**Model:** HCD-H331, HCD-H331D, HCD-H551, HCD-H771, **No. 497**  
HCD-H771D, HCD-H881, HCD-H991AV

**Symptom:**  
**(153)** Sound might be distorted when recording certain Cds. This may occur if the low frequency components on the disc exceed the capacity of the deck.

**HCD-H551/H771  
(MAIN BOARD)**

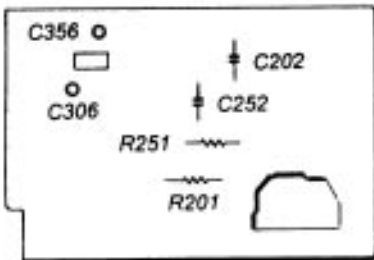
**Solution:** Replace the following components on the main board with new values.

Model No.			Former	New	Part No.
HCD-H551 -H771/D	HCD-H881 -H991AV	HCD-H331/D			
C306, C356		C327, C427	2.2 $\mu$ /50V	Short	-----
R201, R251	R201, R211	R201, R251	680 $\Omega$	15K	1-249-431-11
C202, C252	C202, C212	C202, C252	4700P	220P	1-162-286-31
